Remarks/Arguments

U.S. Patent Application No.: 09/854,712
Amendment dated February 18, 2005
Reply to Office Action of October 19, 2004

Appl. No. 09/854,712
Amdt. Dated January 14, 2005
Reply to Office action of October 19, 2004
Annotated Sheet Showing Changes

Fig. 2

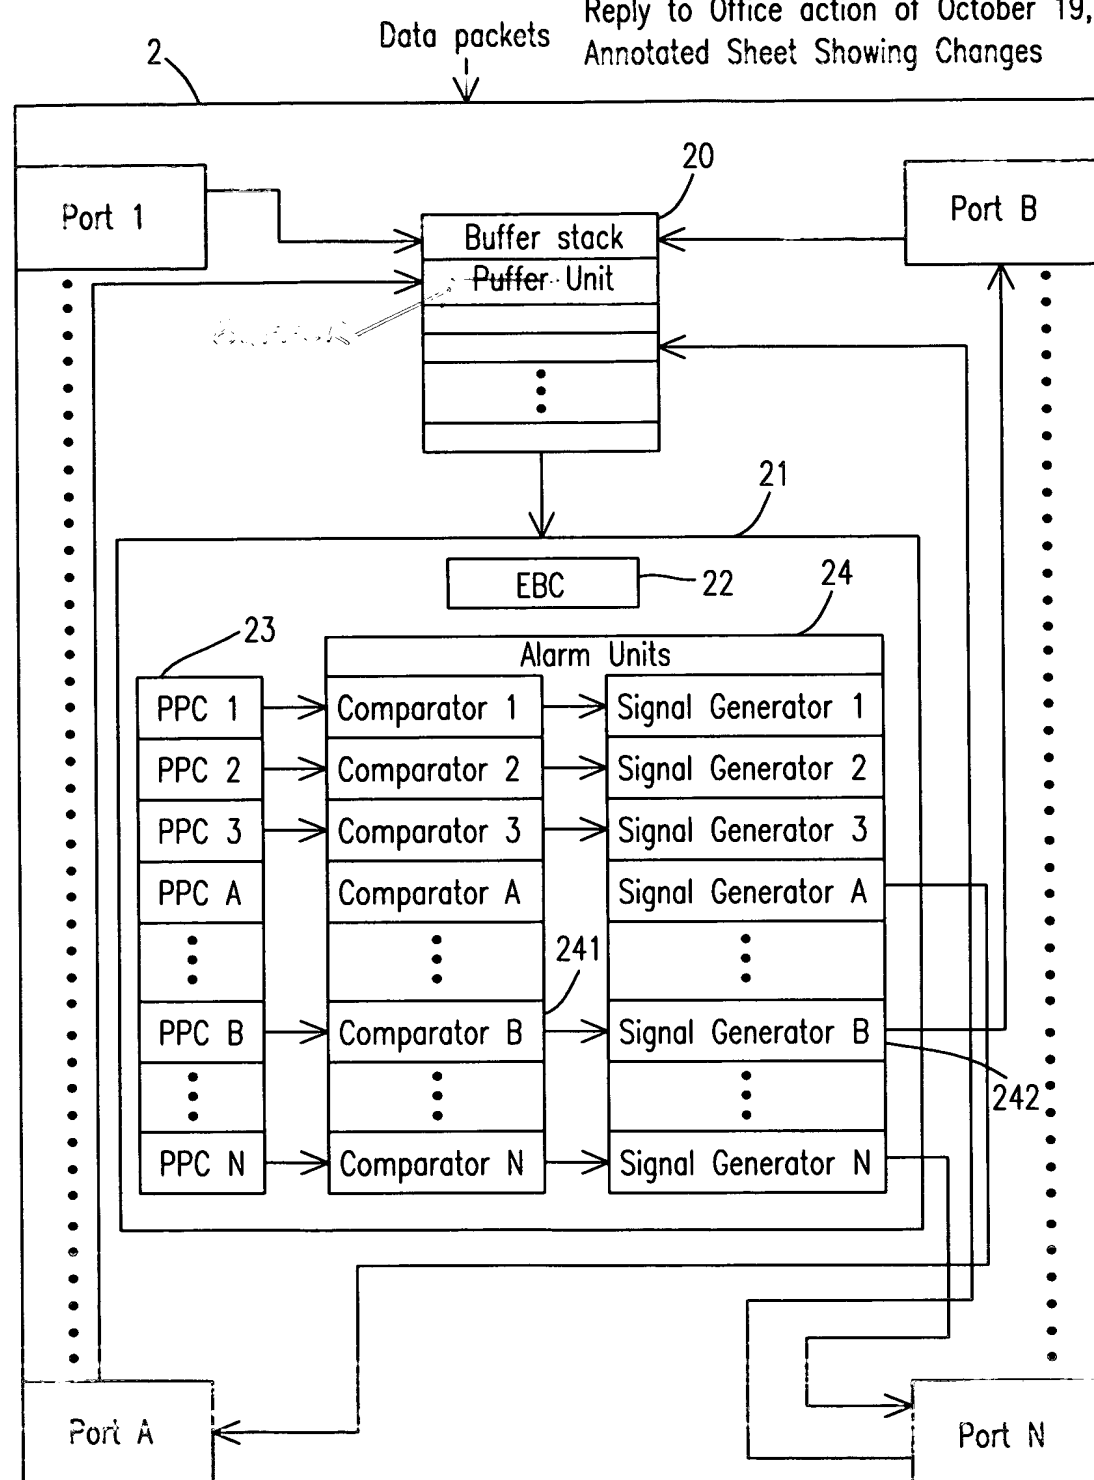
Please replace sheet 2 of the drawings, containing Figure 2, with replacement sheet 2, in which Figure 2 has been amended by correcting the spelling of the word "Buffer" from "Puffer". An annotated Sheet showing the change is also enclosed herewith.
